**ADDENDUM #1
TO THE
TECHNICAL DRAINAGE STUDY
FOR
ESTRELLA @ SUNSTONE**

NOVEMBER 2021

PROJECT 4320.0014

RE: Certification Letter for Paper and Digital Plans for the
Addendum #1 to the Technical Drainage Study for Estrella @ Sunstone

INLET SUMMARY ONSITE				
DROP INLET	BASINS / CONC. PT.	Q100	Q100 (INTERCEPT)	Q100 (BYPASS) (CFS)
DI1	DI2 BYPASS + DI3 BYPASS + DI4 BYPASS + PR6	9	9	0
DI2	PR1 + PR3 + PR4	16	12	4
DI3	PR5	5	3	2
DI4	PR2	8	6	2

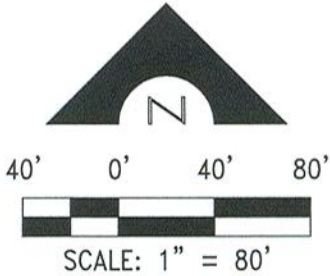
7. **Figure 6: The Q100 for Inlet 1 is shown as 99 on the figure, and as 9 in the calculations.**

The table on Figure 6, as well as the table below, was revised to show the Q100 of 9 cfs for DI1.

INLET SUMMARY ONSITE				
DROP INLET	BASINS / CONC. PT.	Q100	Q100 (INTERCEPT)	Q100 (BYPASS) (CFS)
DI1	DI2 BYPASS + DI3 BYPASS+ DI4BYPASS + PR6	9	9	0
DI2	PR1 + PR3 + PR4	16	12	4
DI3	PR5	5	3	2
DI4	PR2	8	6	2

FIGURE 6
ULTIMATE CONDITIONS MAP

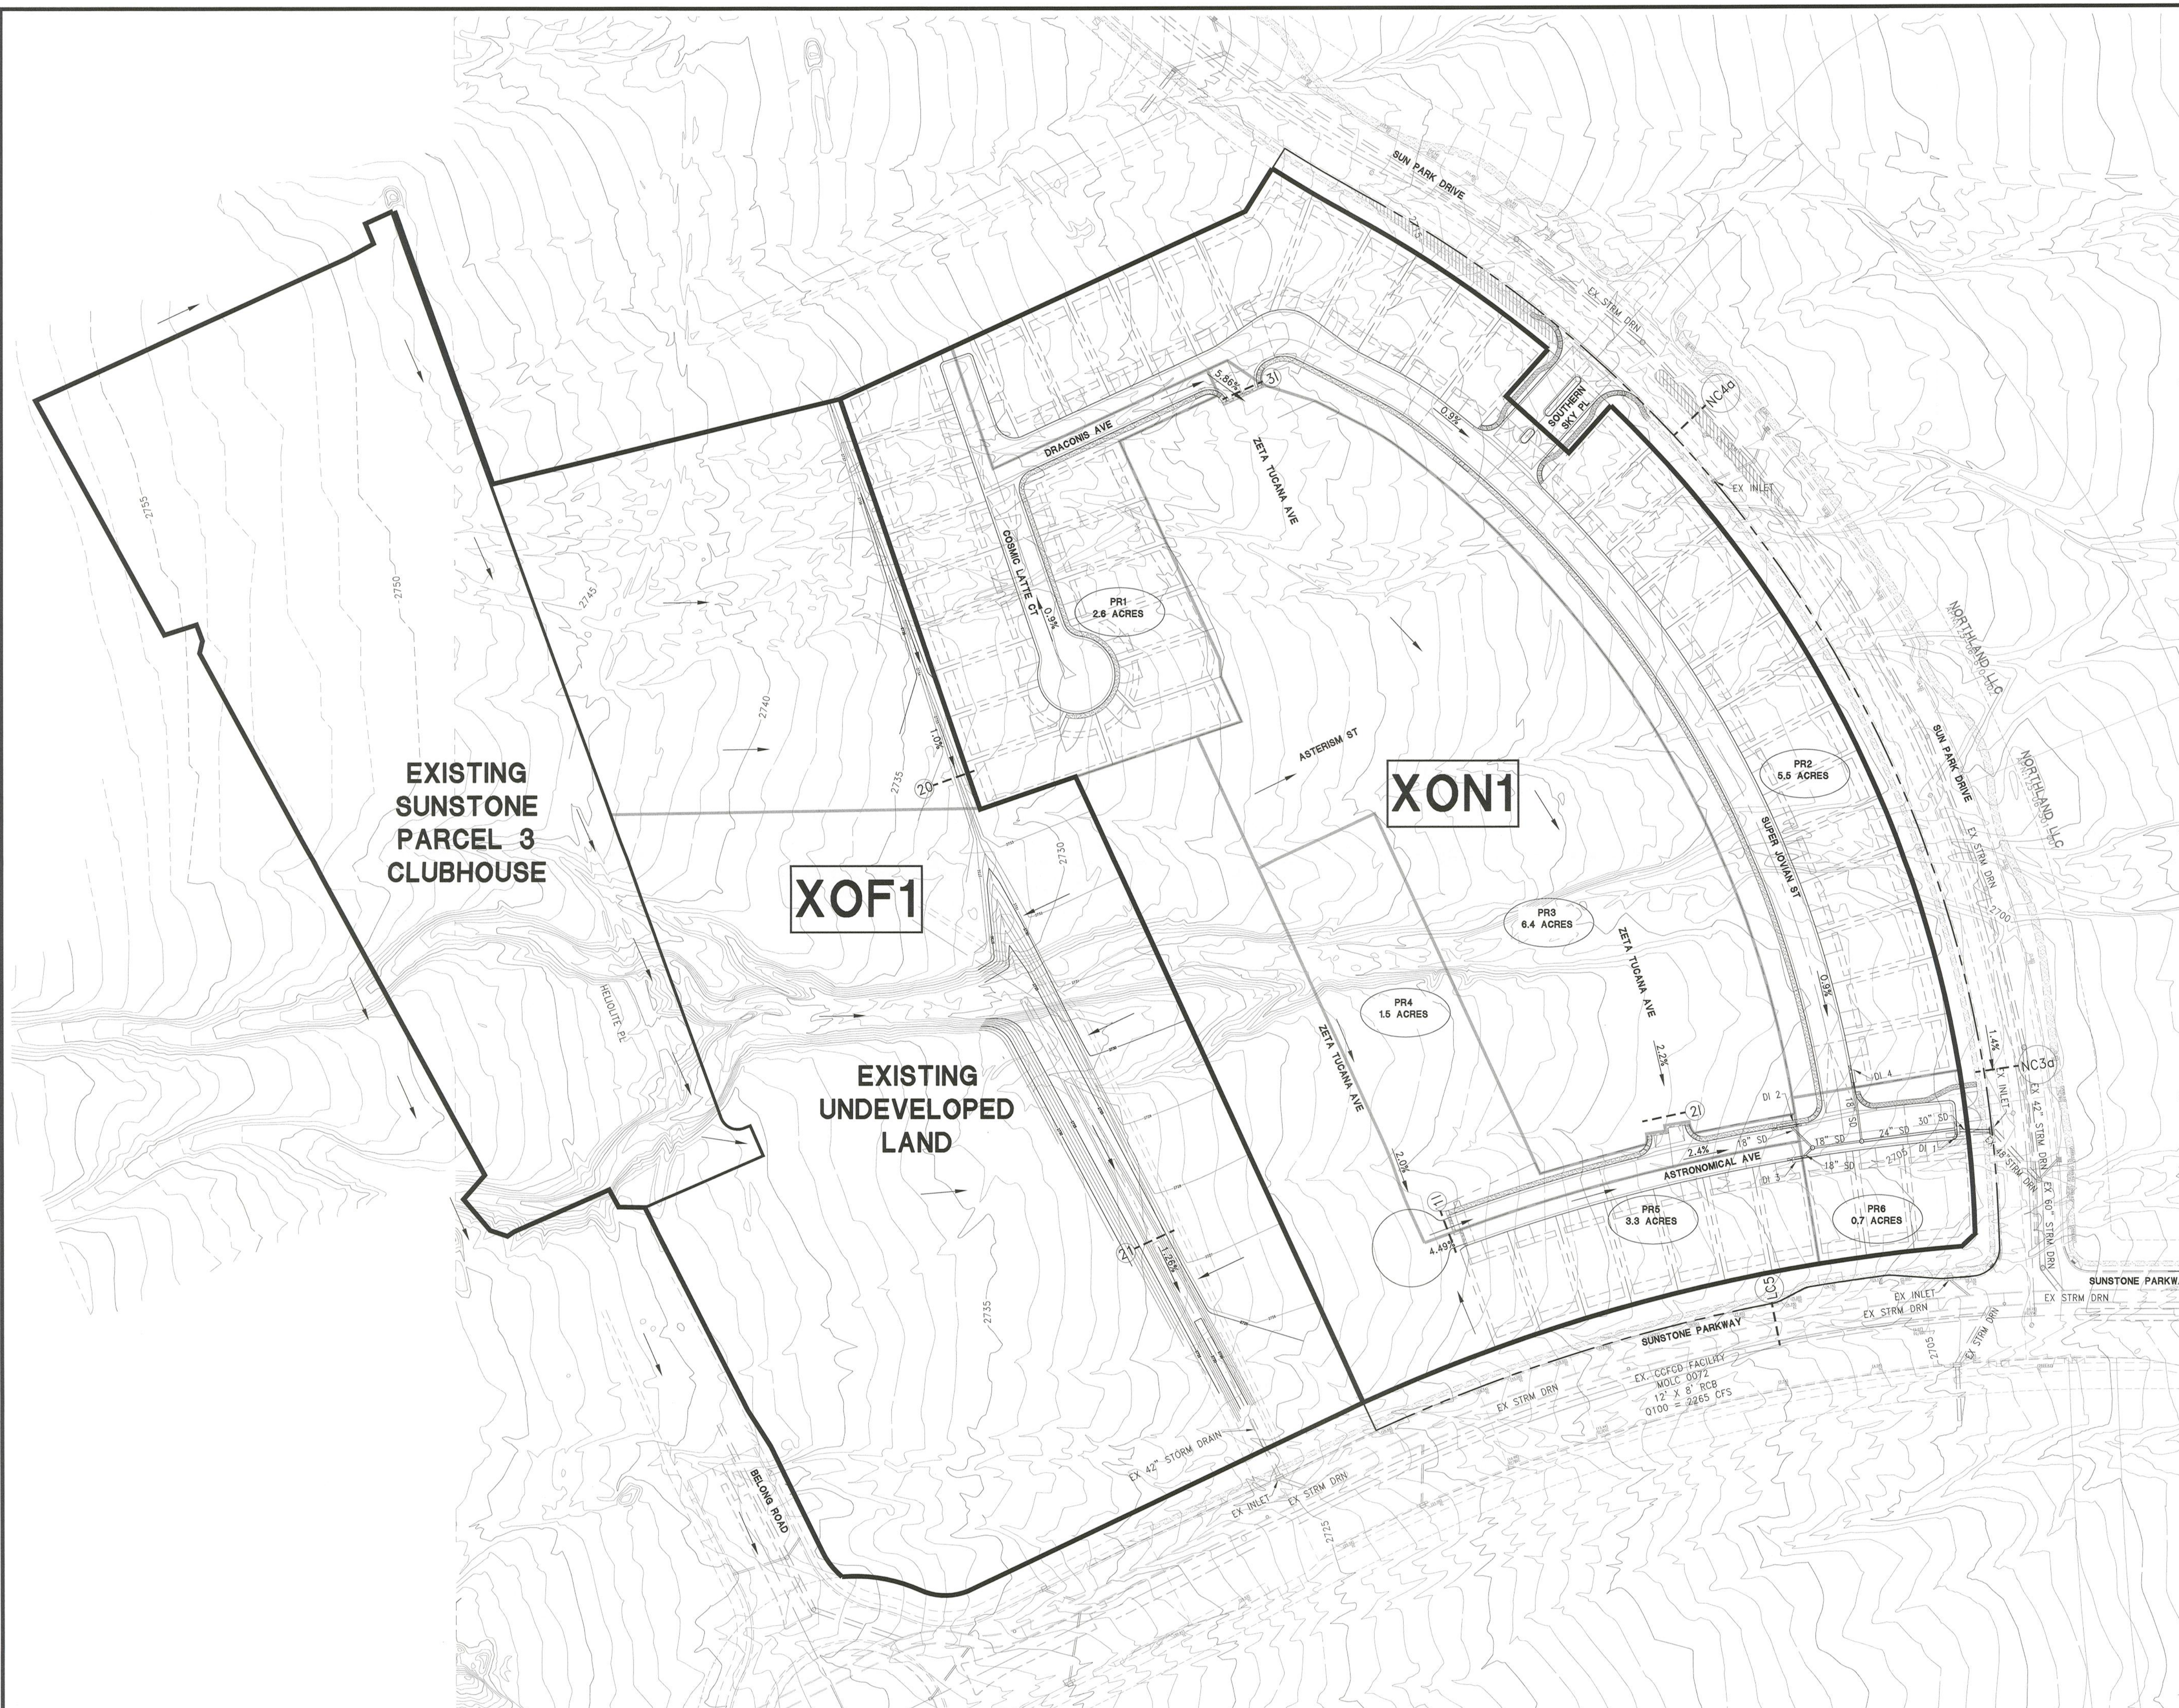
6. **Figure 6: The labels on the map do not match the provided tables, the onsite basin is labeled XON1 on the map, but DON1 in the table.**

The basin label XON1 was revised to DON1 on Figure 6 to match the table.
